ADDENDUM NO. 2

**PORTER TOWNSHIP ADMINISTRATION BUILDING
Valparaiso, IN 46341**

This Addendum forms a part of and modifies the Bidding Requirements, Contract Forms, Contract Conditions, the Specifications, and the Drawings dated August 25, 2026 by Gibraltar Design, Inc. Acknowledge receipt of the Addendum in the space provided on the Bid Form. Failure to do so may subject the Bidder to disqualification.

This Addendum consists of Pages ADD 2-1 through 2-2 and attached Addendum No. 2 from Gibraltar Design, Inc. dated September 18, 2026 and consisting of 5 pages, Specification Section 08 14 32 - Stile and Rail Wood Doors, Specification Section 33 46 16 - Outlet Structures for Stormwater Ponds, and 15 drawings.

**PROPOSED SITE PLAN -
SCOPE B**

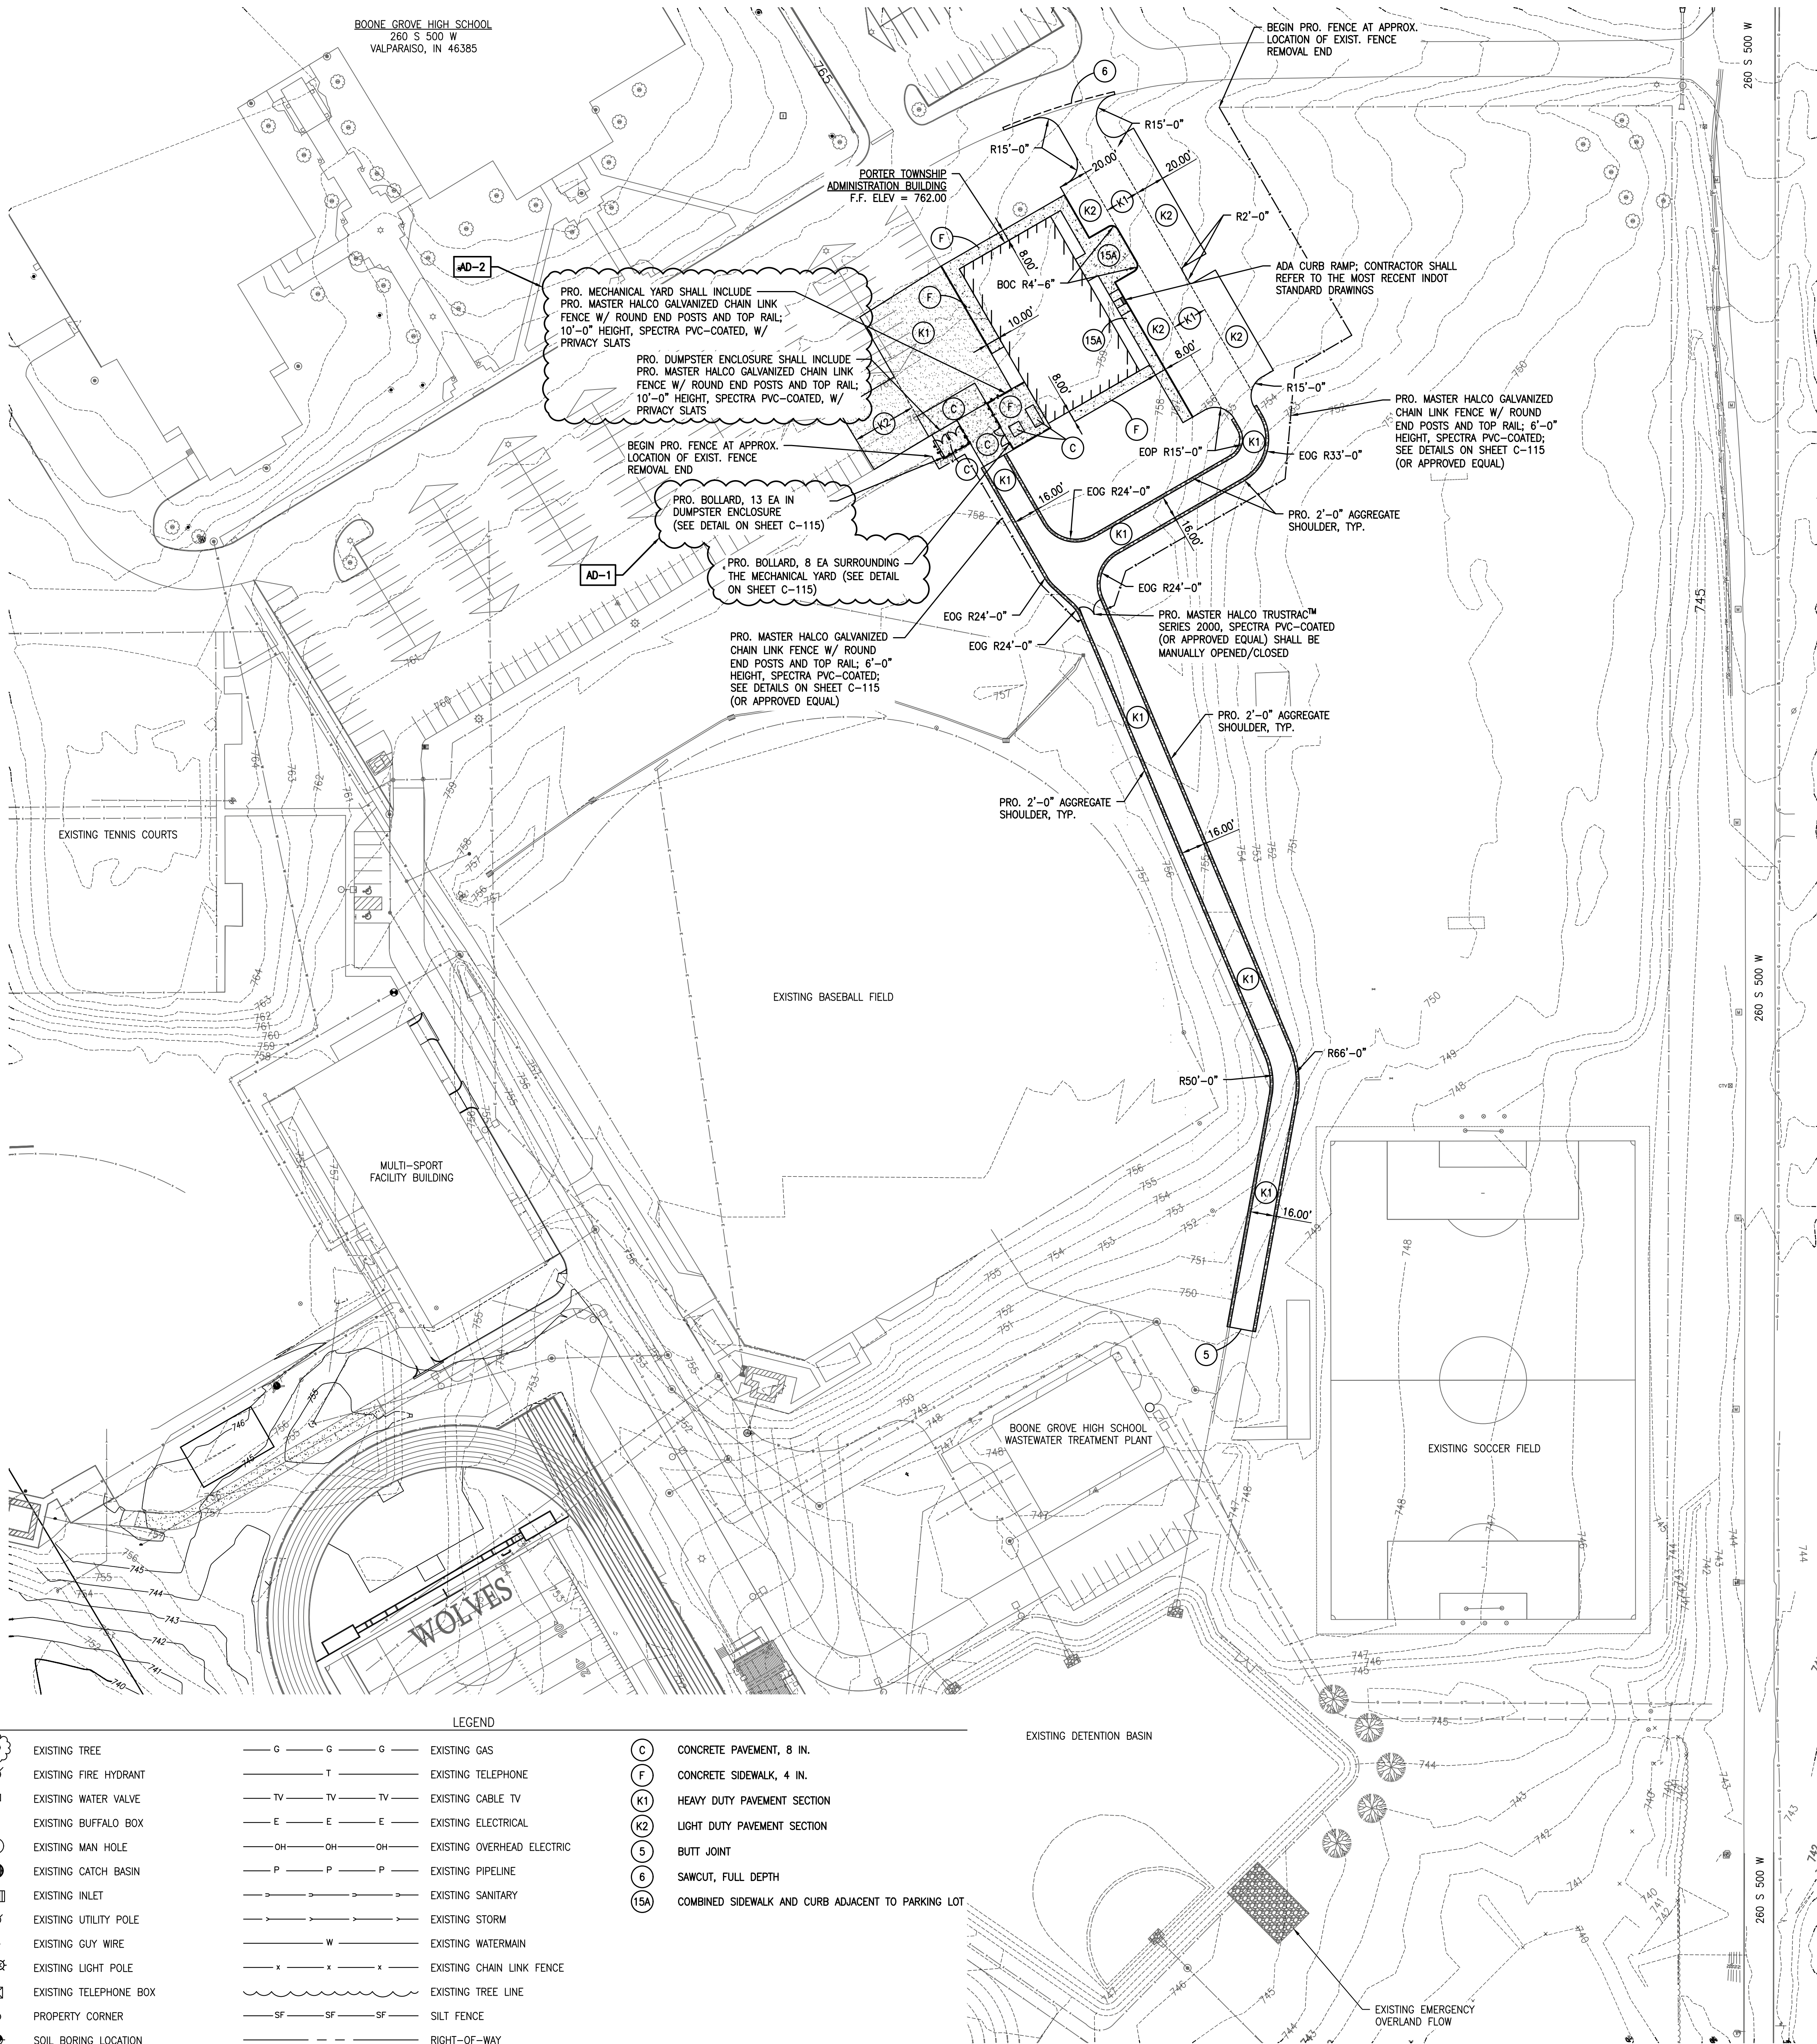
9. Sheet C-102

- A. Refer to revised, full-size drawing, included in this Addendum, for revisions.
 1. Adjusted the height of the proposed fence for the mechanical yard and dumpster enclosure from 8'-0" to 10'-0".

1. ADDED BOLLARDS SURROUNDING MECHANICAL YARD AND DUMPSTER ENCLOSURE.

FLAG POLE SECTION DETAIL

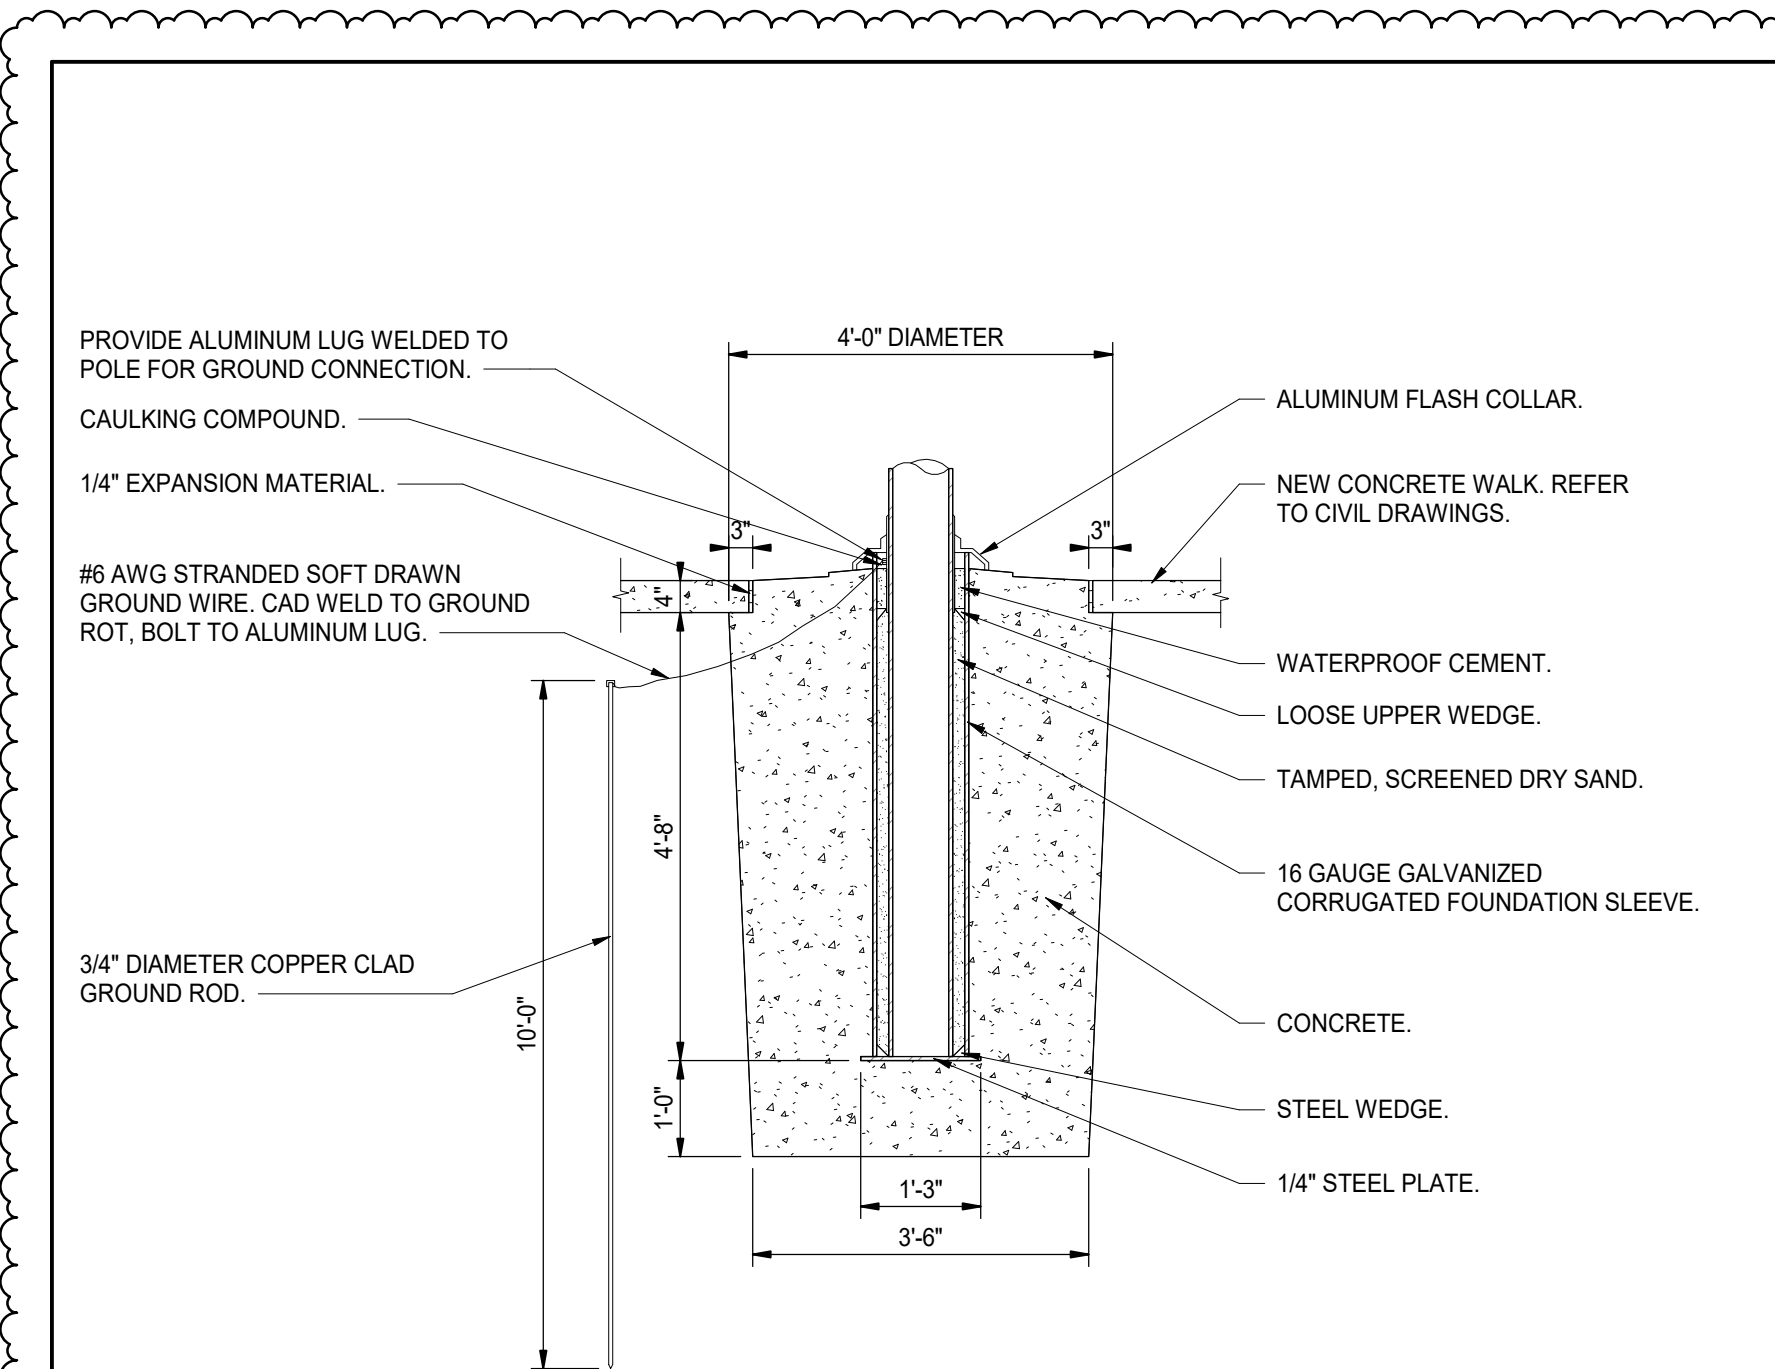
**11. Sheet A-501**

- A. Refer to revised, full-size drawing, included in this Addendum, for revisions.
 - 1. Added flagpole detail.

DRAWING
DOOR SCHEDULE, FRAME PROFILES, ELEVATIONS AND DETAILS

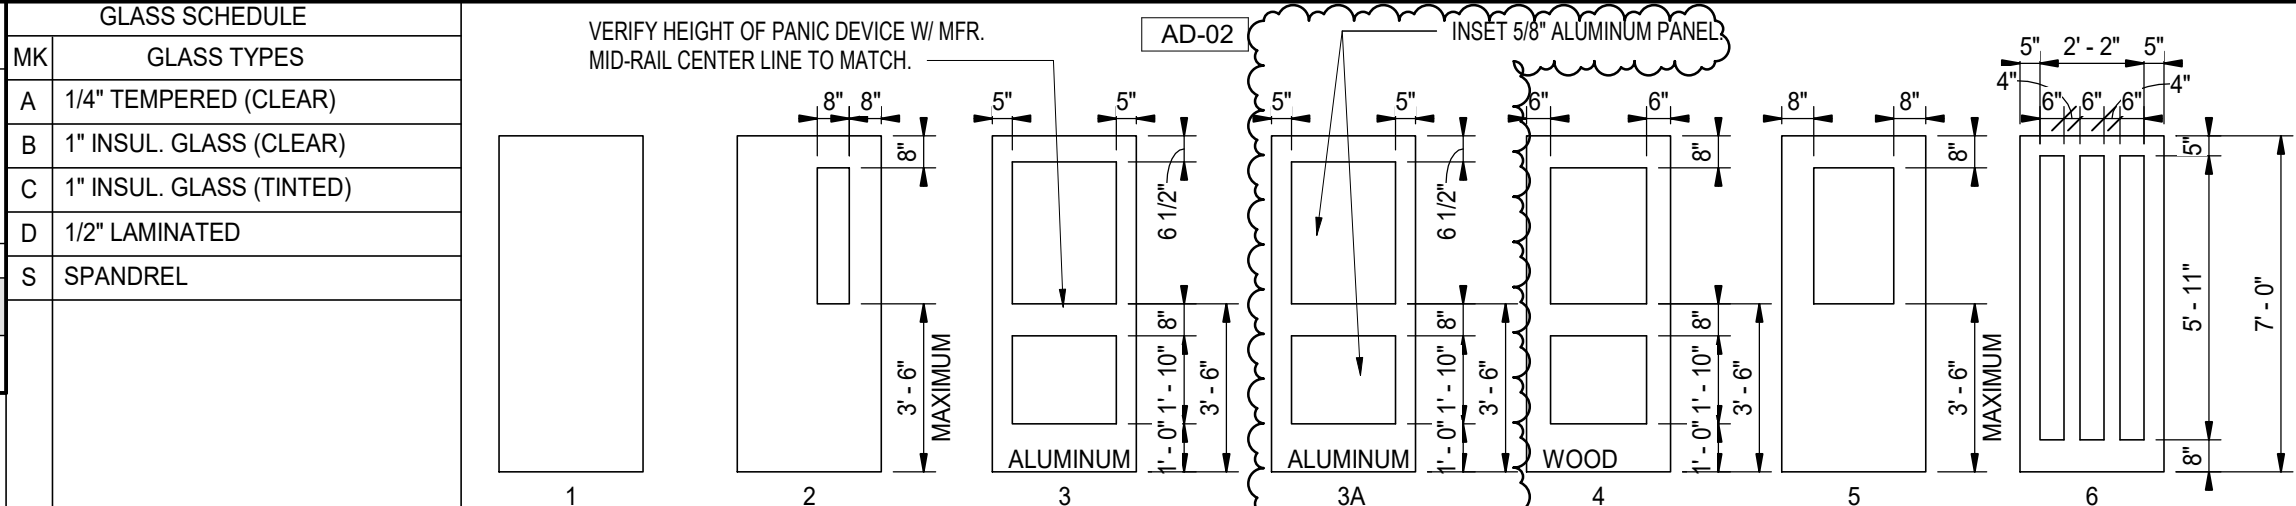
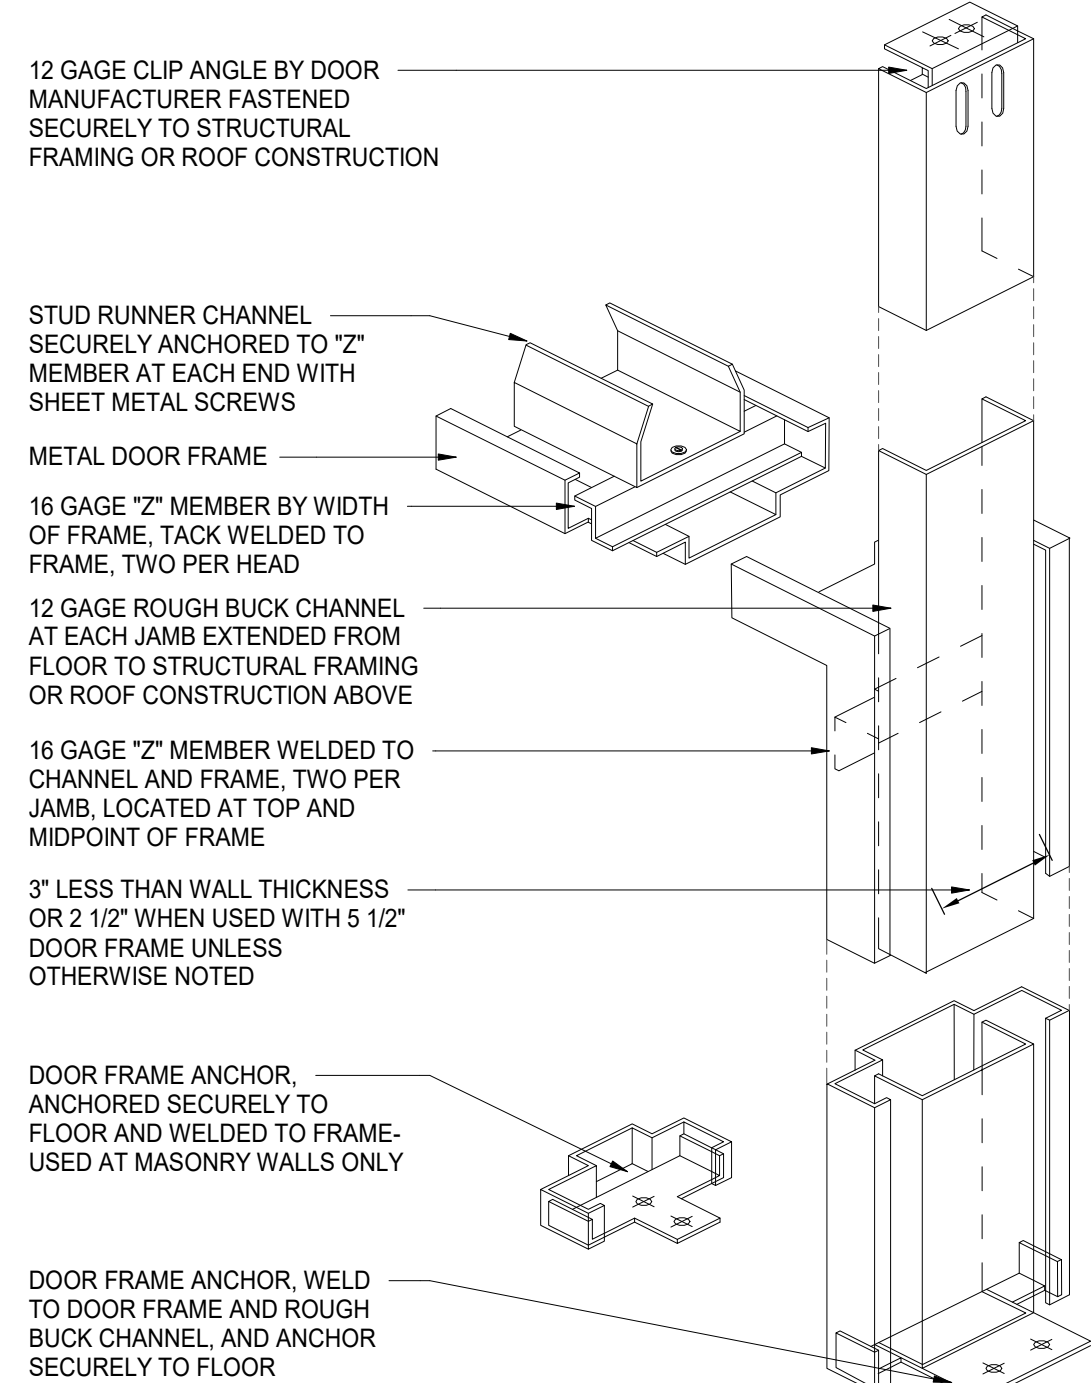
12. Sheet A-601

- A. Refer to revised, full-size drawing, included in this Addendum, for revisions.
 - 1. Door 6 is to be a wood door with 3 rectangular recessed wood panels and trim. See Frame and Door Schedule, Doors A115A and A115B indicate that there is no glazing within the door.
 - 2. Changed door number A125D to A130B.
 - 3. Added door elevation 3A.
 - 4. Added door schedule notes 14 and 15.
